Planning Commission
AGENDA

- 4.a 1925 SANTA BARBARA AVENUE (APPL-0232-2024) APPEAL OF THE COMMUNITY DEVELOPMENT DIRECTOR'S DECISION TO APPROVE ARCHITECTURAL REVIEW APPLICATION ARCH-0448-2022 11

APPL-0232-2024 (1925 Santa Barbara)
 Planning Commission Report – June 26, 2024

A RESOLUTION OF THE PLANNING COMMISSION OF THE CITY OF SAN LUIS OBISPO, CALIFORNIA, DENYING AN APPEAL AND UPHOLDING THE COMMUNITY DEVELOPMENT DIRECTOR'S DECISION APPROVING MINOR DEVELOPMENT REVIEW APPLICATION ARCH-0448-2022 REGARDING DEVELOPMENT OF A MIXED-USE PROJECT AT 1925 SANTA BARBARA AVENUE (APPL-0232-2024)

Figure 3: Pattern Study (from Project Plans), West Side of Santa Barbara Avenue

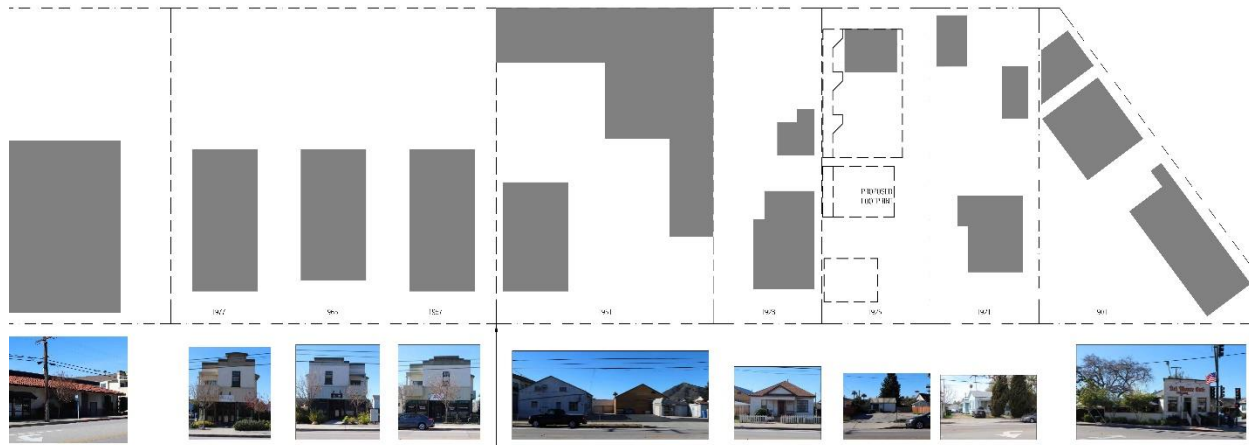
The pattern of development in the vicinity of the project site and along the west side of Santa Barbara Avenue are further discussed in the appellant's statement. The appellant notes that the Railroad District Plan makes no explicit distinction between portions of Santa Barbara Avenue that are north and south of Upham Street, though they lie within different Zones and are subject to different development standards. The predominant building type and pattern of massing and spacing south of Upham is described in the appellant statement, and it is suggested that projects adjacent to historic resources should provide deep rear setbacks and concentrate building height at their west (Santa Barbara Avenue) side, as more appropriate and consistent with the area.

The Railroad District Plan explicitly refers to the City's Zoning Regulations for descriptions of applicable property development standards (see Plan, pg. 33) and provides no specific standards for building setbacks or height for new development. Guidance on building setbacks is limited to encouraging new residential buildings to generally maintain the prevailing setbacks of older houses and apartments along Osos, Santa Barbara, and Church streets (Plan, pg. 82), an area that lies north of Upham Street, in a Medium-High Residential (R-3) Zone.

The project was found by the Community Development Director to conform to the development standards applicable to the Service Commercial (C-S) Zone in which it is located, including standards for building height and setbacks, lot coverage, and parking requirements. Zoning Regulations set no rear setback standard within the C-S Zone, but require that, where a site is adjacent to a zone with minimum setback requirements, a setback be provided as in the zone of the adjacent property.¹⁰ In this case, the site is adjacent to a Medium-Density (R-2) Zone, and therefore a minimum setback ranging from five feet (at the ground floor) to ten feet (at the upper levels of the building) must be provided.¹¹ Furthermore, the project is subject to “Edge Condition” provisions in the Zoning Regulations,¹² to provide a buffer between commercial zones and adjacent lower intensity residential zones. An enhanced building setback ranging from ten feet (at the ground level) to twelve feet (at the upper levels of the building) is required at the rear of the site, adjacent to the residential uses behind it. This project exceeds this requirement, providing a twelve-foot rear setback for the whole building, from the ground to its upper levels.

Given these facts, neither the project’s building height nor setback from the adjacent residential zone would provide a basis under the City’s applicable development standards or historical preservation standards to require modification of the project design or to deny the Architectural Review application.

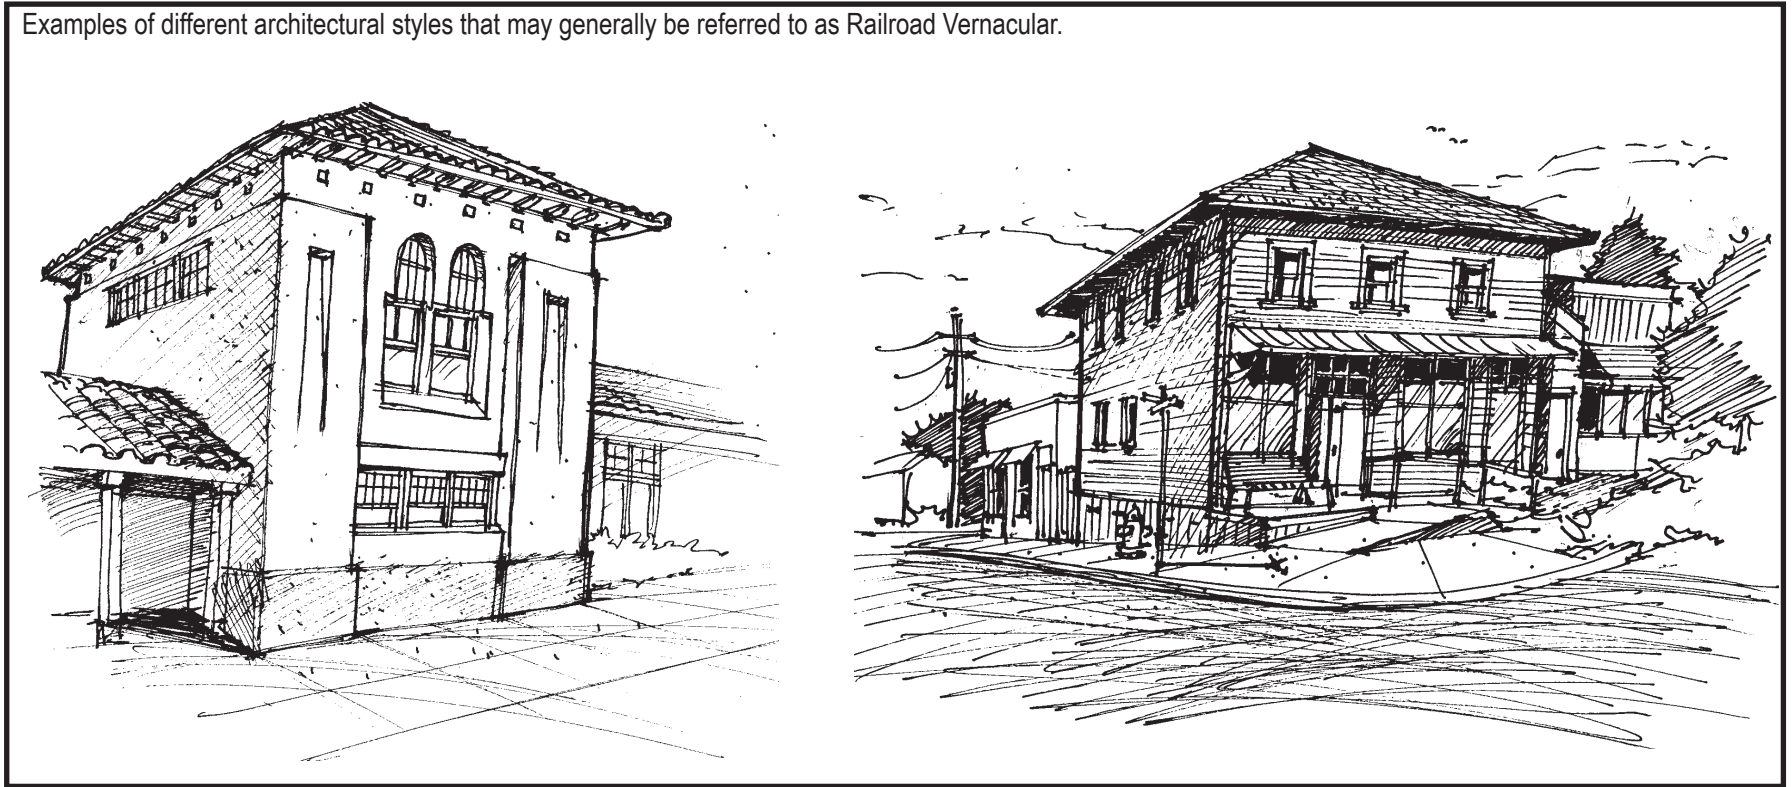
I understand from planning staff that the planning department has noted a north and south side of Santa Barbara Street with a delineation of Upham Street dividing this part of the Railroad District into two patterns of development. It was shared with me that each area is subject to different standards for height, coverage, setbacks and so on. I do not see this delineation referenced in the Railroad District Plan, however, if indeed this is the case I would note that on the west side of Santa Barbara between it's intersection with Broad and up to Upham – the predominant building type is commercial, the predominant height is single story and the pattern exhibited by massing and spacing is significantly different than the proposed project. In addition, commercial properties in this area which have developed with a residential component, the highest elevations are on the east side of the development adjacent to Santa Barbara and there are wide setbacks to the low density development to the west (on Chorro Street). Mimicking this type of development adjacent to Master List historical resources would be more appropriate and consistent with the area.

I believe that placing three story multifamily residential units (with a partially undergrounded 1st story) at the minimum setbacks from low density Master List Historical resources does in fact negatively impact these resources. According to the City's Context Statement, such resources are significant not only because of the building themselves but because of the story they tell and how they contribute to the community. The proposed development is neither consistent with the established pattern nor in accordance with the Historical Preservation ordinance and guidelines.

Figure 5: Original north elevation design.

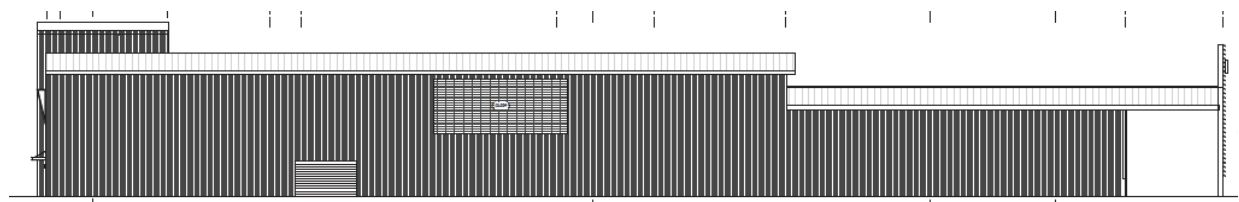
Figure 5: Revised north elevation with additional window fenestration and wood detailing.
